GRADING AND EROSION CONTROL PLAN 208 CUNNINGHAM DRIVE

GRADING AND EROSION CONTROL PLAN			
JOB NO.	FV21181	ORG. SUBM. DATE	12/22/2023
DWN:	JMP	CHKD:	DW
NAME

COVER SHEET

GRADING AND EROSION CONTROL PLAN
JOB NO. FV21181
ORG. SUBM. DATE 12/22/2023
DWN: JMP CHD: DW
NAME
FINAL GRADING & EROSION CONTROL PLAN
NO. **C3.0**

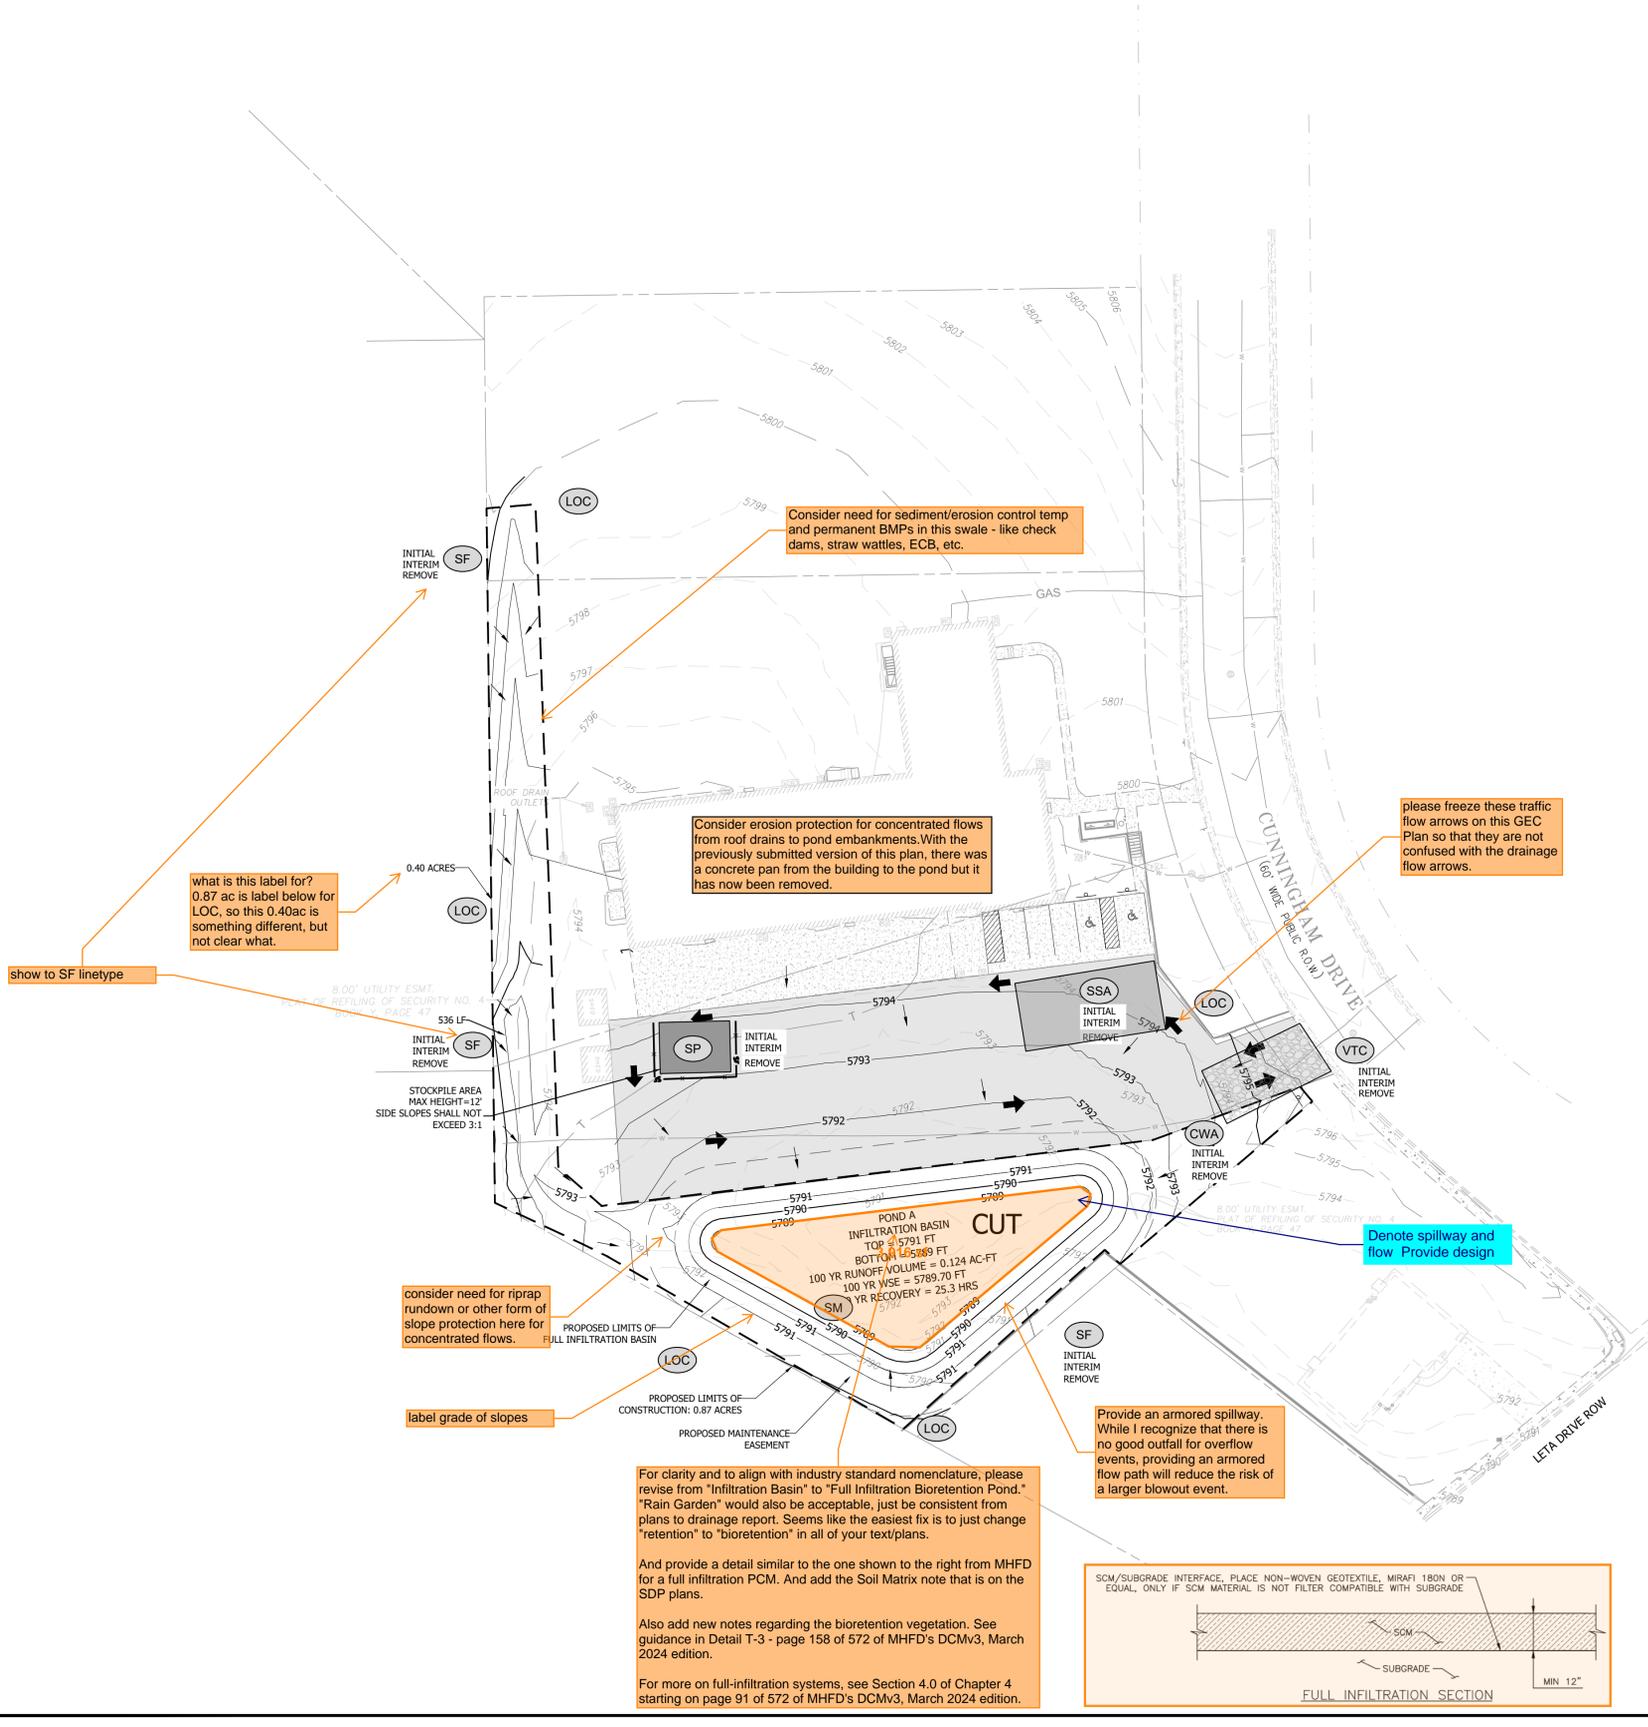
Add spillway standard design
